The Horns Public House

HERITAGE IMPACT ADDENDUM

Document No: 1320-HR-A-TP-XX-0002

- 1.1 This Addendum is submitted to summarise responses pertaining to comments received 31.01.2025 from the Built Heritage Officer for Wokingham Borough Council (WBC) regarding application 242954 *“Application for Listed Building consent for the proposed external alterations to the building, including changes to fenestration and erection of a single storey canopy roof to the side; internal refurbishment of the bar area; removal of 3 no. chimney breasts at ground floor and associated structural works; structural works to the existing ground floor timber frame and 1 no. ground floor chimney, toilets and first floor rooms; new signage to the main elevation and a replacement roadside post sign.”*

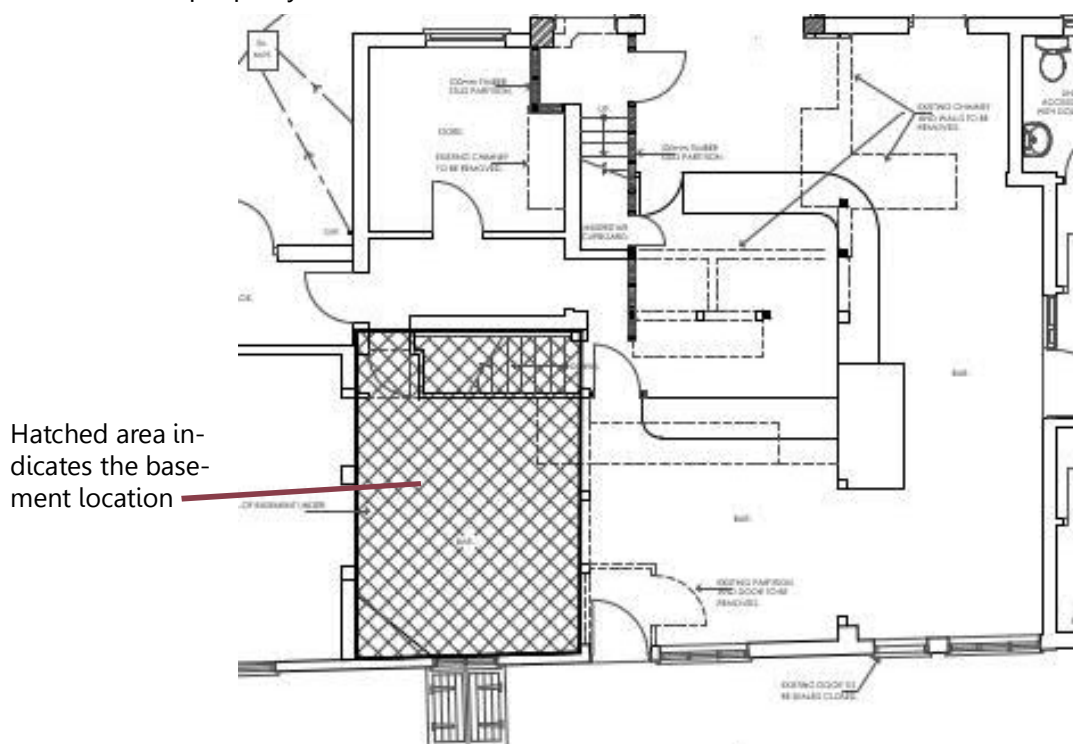
"the concern is with respect to the intended structural works to support the upper floor- Of greater concern with the proposal structural steel is that this proposal calls for the removal of parts of the timber framing around the historic doorway... in order to accommodate one of the supporting posts it is intended to 'notch' the historic beam proposed to do so. Built Heritage strongly object to this loss and alteration of historically significant timber frame components pertaining to the earliest phase of this property."

The proposed steel design - as per drawing 1886-21 P in the application - has been revised from partially relieving the load, to entirely relieving the loading upon the historic timber frame - refer to drawing 1886-21 P1 - by the introduction of a second cantilever which reduces the masonry proposed to be cut away.

As explained in the accompanying Structural Engineer's Advice Letter enclosed (refer to the Appendix) the notch in the existing timber is required to stabilise the existing frame, to avoid the need to remove more of the timber frame that would become more unstable, or remove the timber entirely to avoid collapse. The proposed design seeks to do as little as possible to the existing historic structure, whilst achieving a safe solution for the building and securing its viable longterm retention, without which the building may remain propped and unusable.

View of rear courtyard location of proposed extension under application 171384

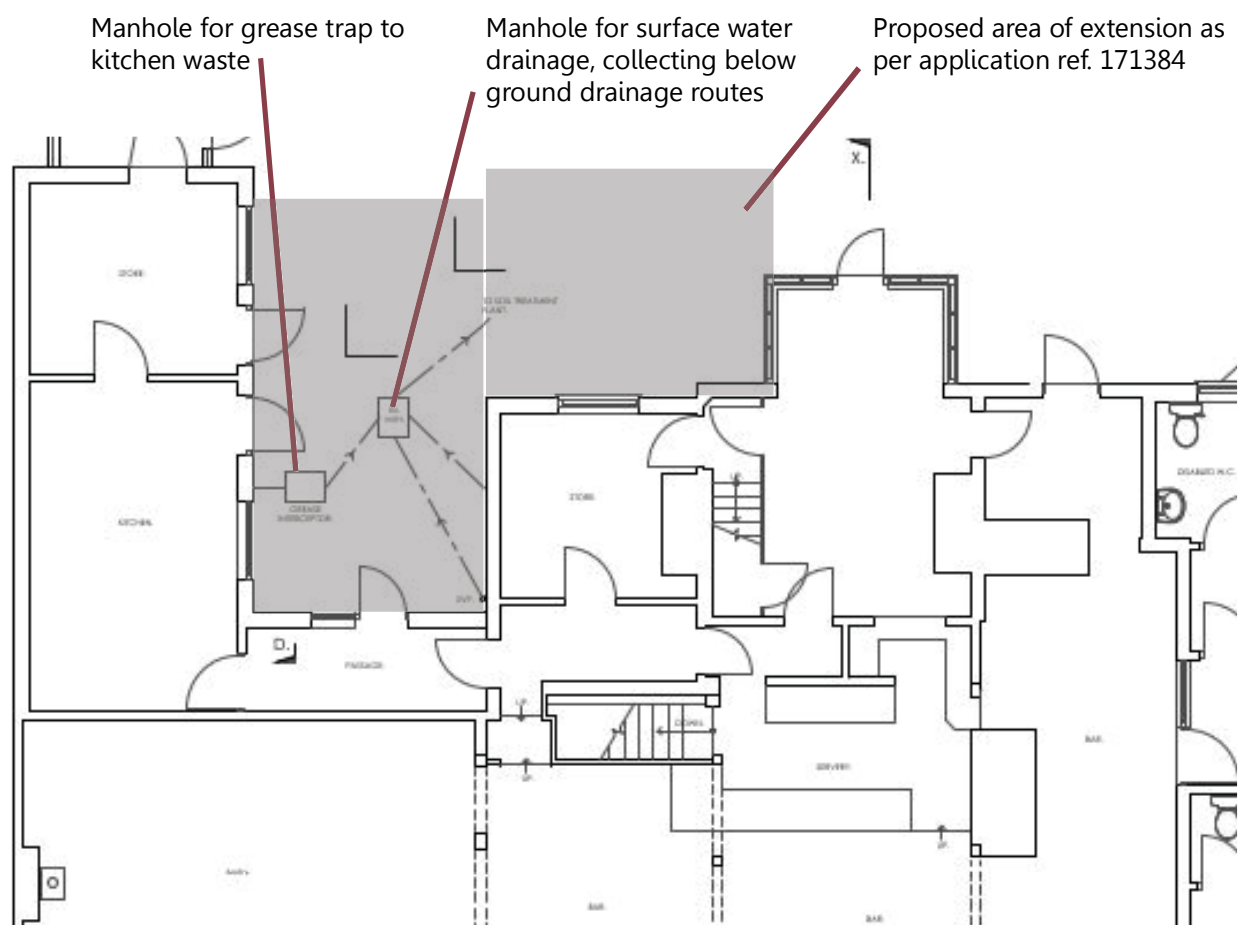
"Planning permission had been given in 2017, under 171384, for a large rear single storey extension to be built off the existing modern service corridor to the kitchen that runs along the back of the barn. From a heritage stance that unimplemented scheme had had merit to in that it left unchanged to the historic planform layout of the ground floor and provided further the additional trading space in the new extension. As such it is somewhat disappointing from a heritage stance that the applicant had not taken that option as opposed to the much greater harmful approach to this designated heritage asset that appear driven by costs."

Secondly - but critical with respect to the economic viability for the resurrection of the operation of the pub - the proposed extension under 171384 would have been located over existing drains and the grease trap for the commercial kitchen; the external ventilation system adjacent that serves the kitchen which would require to be located - refer to Image 23 of the Heritage Statement, and the image below.

The practical construction costs to execute the lapsed permission 171384 with associated construction challenges, in an era of recognised increasing inflation within the construction industry, would cause the build-costs to be economically unachievable for the community owners.

Extract from drawing 1886-01 P

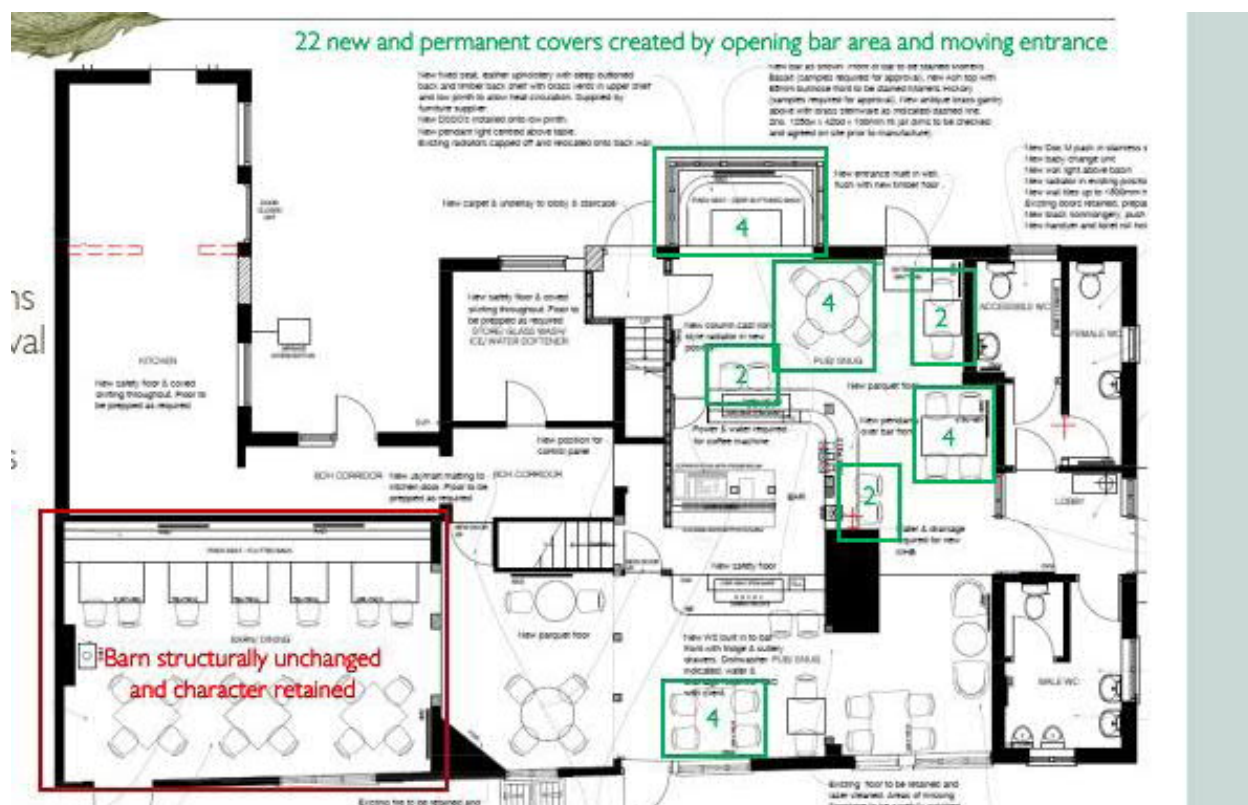
"Built Heritage raise objection to extent of internal walling and chimney breasts that it is intended to be removed on the ground floor. These works would impact the 19th century phases of expansion of the original building. Whilst in age and significance of less importance than late 16th century historic core or that of the attached barn structure these 19th century extension to the rear and north-eastern end of the public house are thought to be more than 150 years old and are considered to hold a degree of historic significance due to their age and in their contribution to the historic phased development of the building. As such, given removal of historic fabric/features further diminishing an already much eroded historic ground floor planform/layout of this designated heritage asset."

As stated in the Economic Analysis document, the internal alterations account for a 50% increase in the number of dining 'covers' that can be accommodated, of this over 1/3 (8no.) seats are directly attributable to the removal of the chimney breasts and associated walling, whilst the remaining increased number of covers have predominantly been gained by the spatial efficiency and internal flow of the connected spaces, currently cellular in character and disconnected in operation and utility. All covers are proven in the document to be necessary for financial viability.

Extract from the ventilation drawing for Guest Bedroom 2

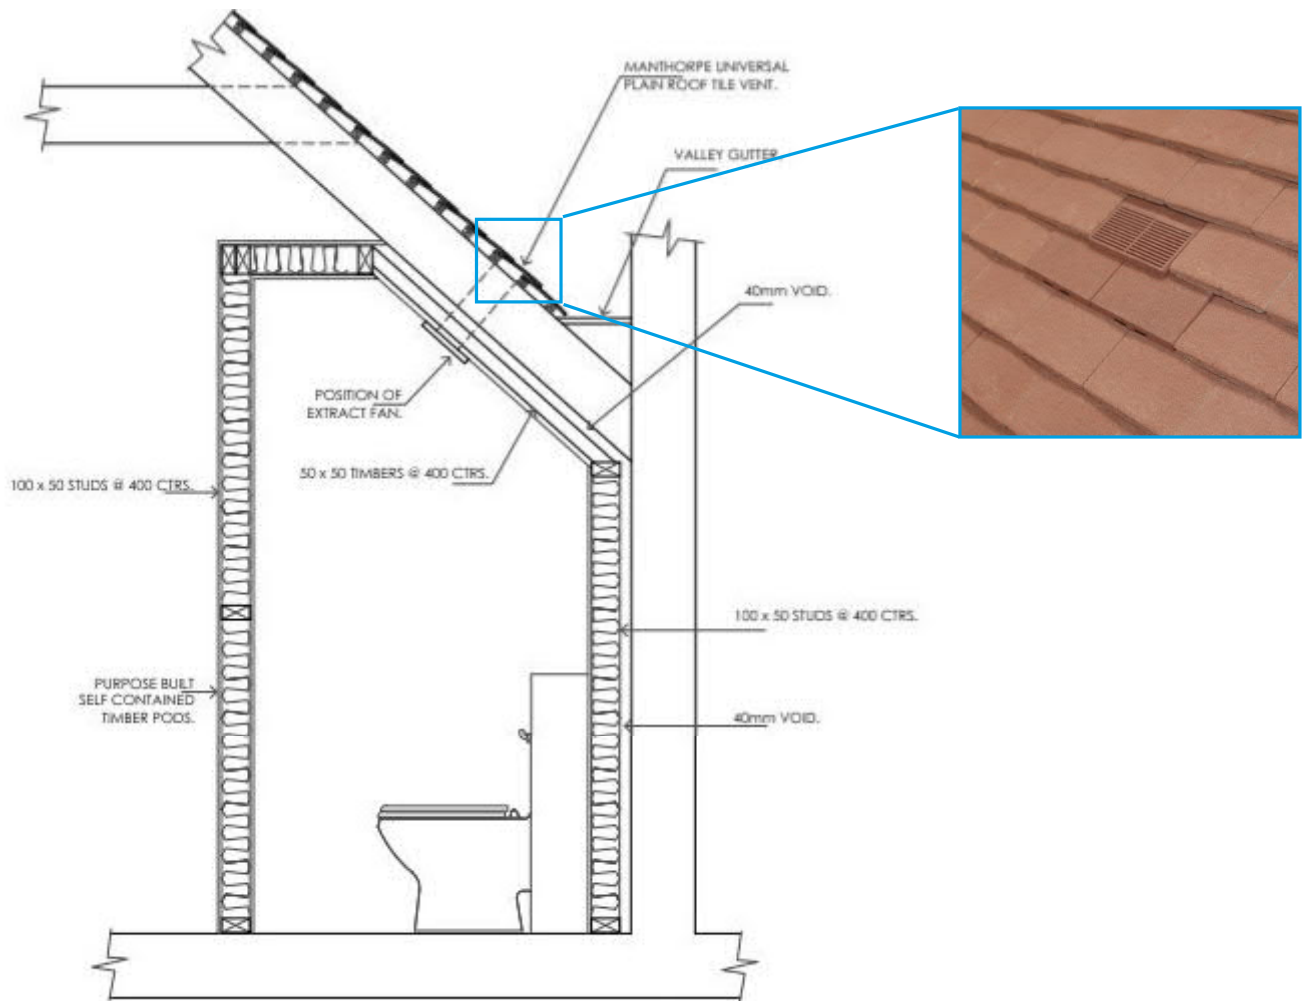
"...concern in both the form for the ensuite bathroom and the lack of sufficient details with the respect to the provision of services/pipework needed for them or details as to how extraction ventilation for the ensuites would be provided given that these two rooms form part of the most historically significant part of the property."

Additional details for the ventilation design are provided in drawings 1886-18 P and 1886-19 P, refer to the extract of drawing 1886-18 P, below. The floor is a modern timber floor and therefore the drainage will not cause harm to historic fabric - refer to 4.5.1A of the Heritage Statement.

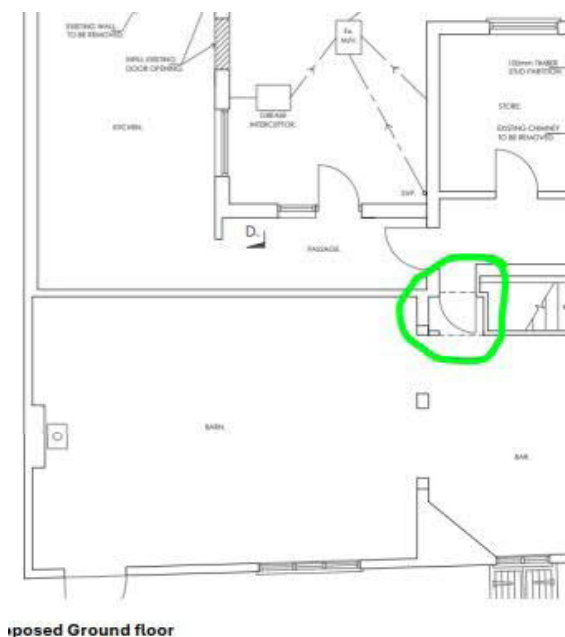
"Floor plan drawing showing existing and proposed do not show the existing door to the cellar stairs"

Drawing updated to show cellar door - refer to drawing 1886-05 P1.

Extract from Proposed GA Ground Floor Plan 1990

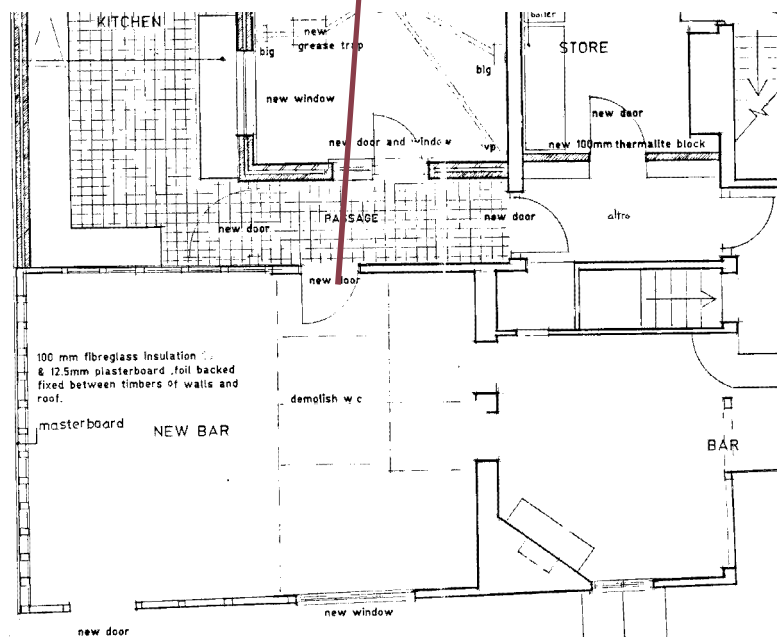
"Drawing 1886-05 P (Proposed Alterations and Refurbishment) show the doorway adjacent to the cellar entrance that gives access to the back of house areas from the bar would as a result the intended new partition walling be reduced down to 600mm width opening (with no frame and/ or door to it) as best measured from the drawings."

Comments made regarding the width of the door are noted, and it is not intended to alter the existing opening width. Should, for any reason, the door not work in practice, there is precedence for a door within the wall of the bar directly from the service corridor in the proposed (and approved) 1990's plan.

Extract from drawing 1886-20P

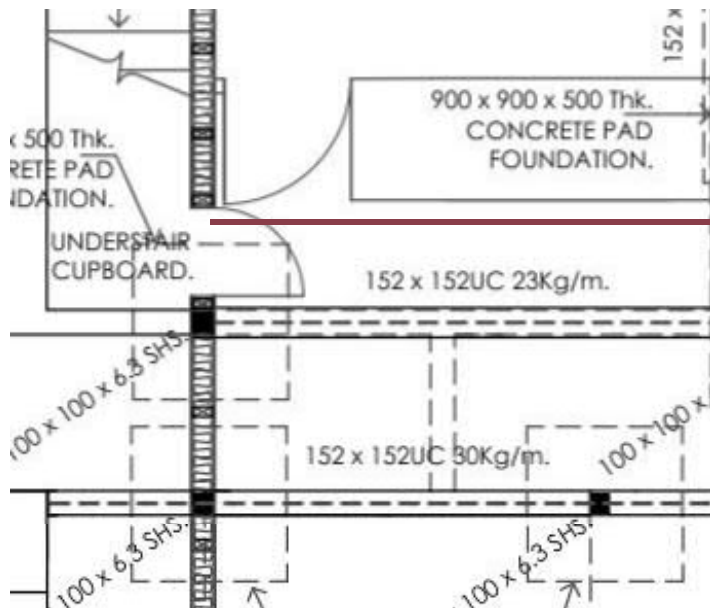
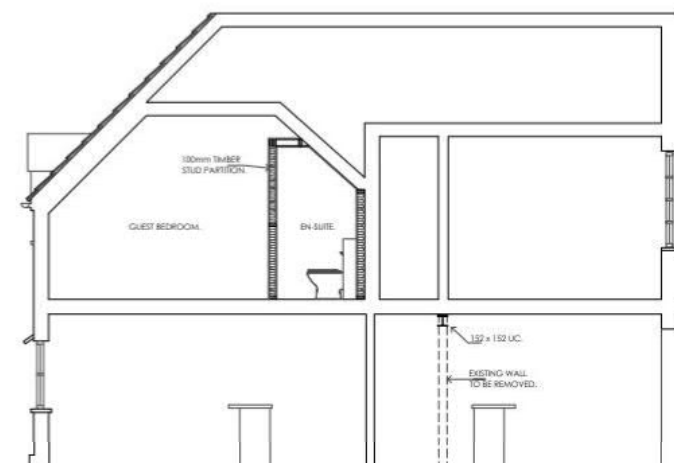
"With respect to drawing 1886-05 P and that for the Ground Floor Structural Plan (drawing 1886-20 P). The latter drawings shows a post to the edge of the bar top in line with that of the end of the intended partition wall (with calculated 650mm wide access doorway to the bar). Whilst the position of this post on the other drawing is shown off-set from the end of the partition wall."

The post referred to in drawing 1886-20 P was drawn in error, this has been removed in the revised drawing '1886-20 P1'.

Post drawn in error - now removed in updated drawing

Extract from drawing 1886-10P1

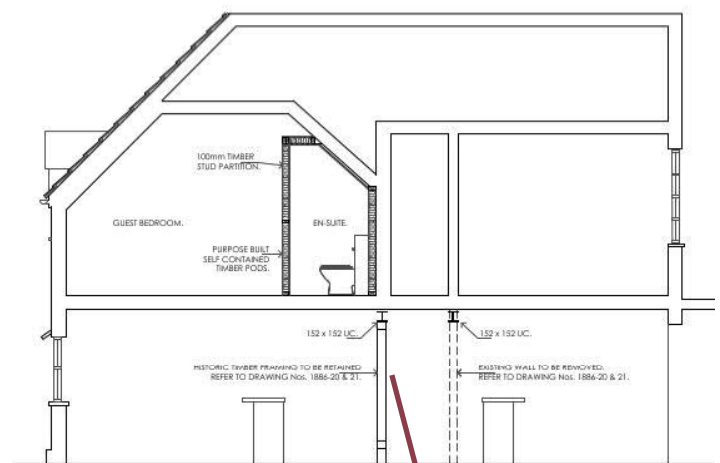
"Cross sectional views as proposed shown on drawing 1886-10 P, appears to depict a wall still remaining where walling is to be removed."

The wall referred to in drawing 1886-10 P was drawn in error, this has been removed in the revised drawing '1886-10 P1'.

Wall section updated

Extract from page 12 of the Heritage Statement

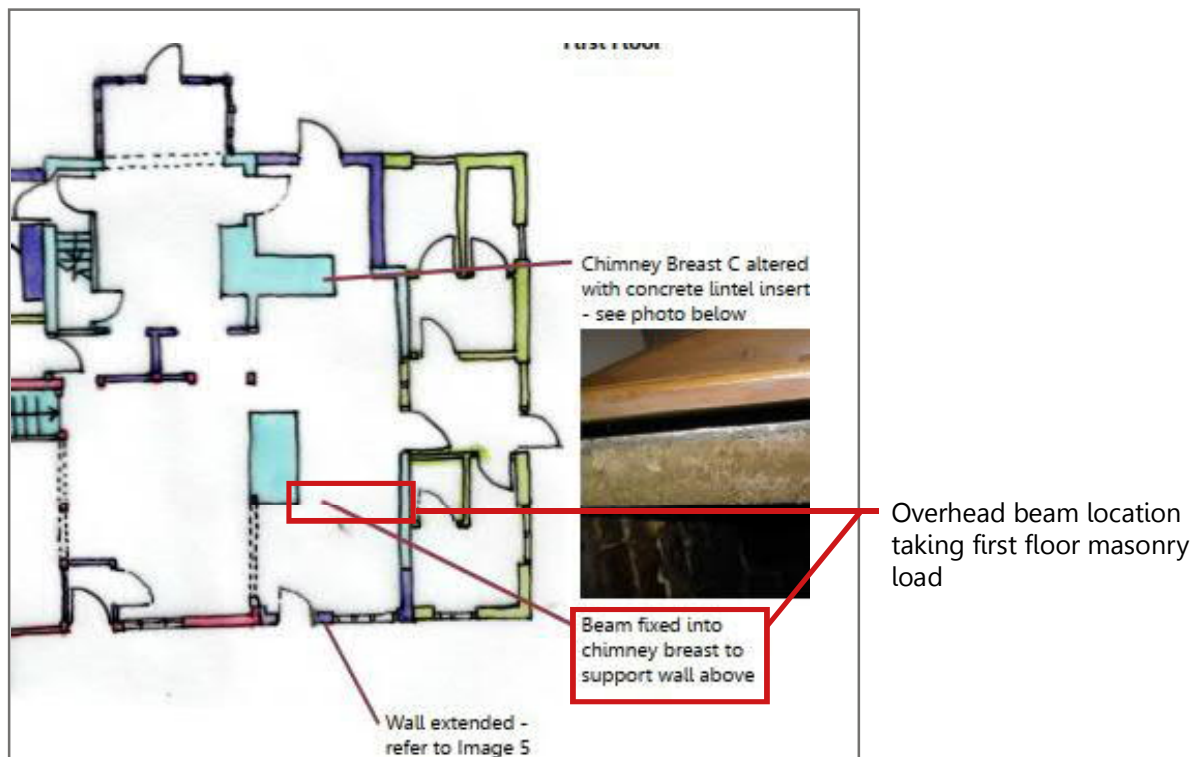
"Drawing 1886 - SK01 P (Helibar Detail to Existing Chimney) has been provided which on it does not clarify where in the building the intended works are for... In principle the proposal is believed acceptable although question is however raised to the state mortar mix to be used. The expectation here is for the mortar to be a lime mix"

The notes to drawing 1886 - SK01 P have been updated to clarify that the pointing shall be as follows: "POINT UP JOINT IN 1:3 LIME MORTAR. (1 PART NHL 3.5 : 2 PARTS BUILDING SAND, 1 PART SHARP SAND);

PLASTER EXISTING CHIMNEY WITH 10mm BACKING COAT 1: 2.5 LIME PLASTER (1 PART NHL 2 : 2.5 PARTS BUILDING SAND.); 3mm FINISH COAT 1:1.5 LIME PLASTER (1 PART NHL 2 :1.5 PARTS FINE SILICA SAND.)" - Refer to 1886-SK01 P1.

The grout directly in contact with the helibars are required to be in a cementitious resin mix to bond and transfer the strength to stabilise the building: when extending the building a steel beam was inserted into the side of the chimney to support the first floor masonry above. This has transferred excessive load onto the chimney which now needs to be structurally stabilised as per the repair proposal - refer to the extract above from the Heritage Statement which indicates the beam location.

Extract from drawing 1886-06P1

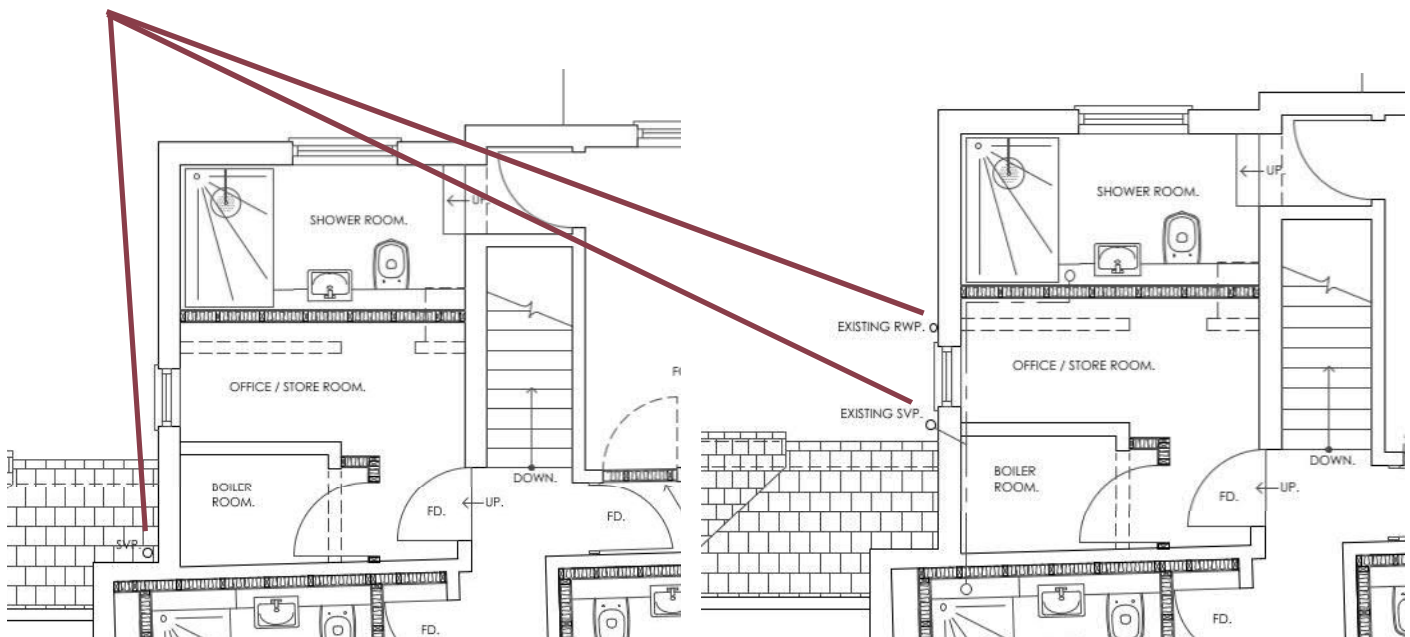
"The intention is for a new SVP, shown on drawing 1886-06, sited externally on the rear walling to the historic frontage range, of the first floor (LHS) guest bedroom, and that of the flat-roofed 20th century extension. This SVP is not however shown in the corresponding elevational view (Proposed Elevation E-E) on drawing 1886-08 P although it appears the existing one is. As such further clarification as to the routing externally of the new SVP would be expected to be confirmed, including whether the existing is being kept."

Downpipes updated

Elevation drawing 1886-08 P is correct, the drawing 1886-06 P has been updated - refer to drawing 1886-06 P1.
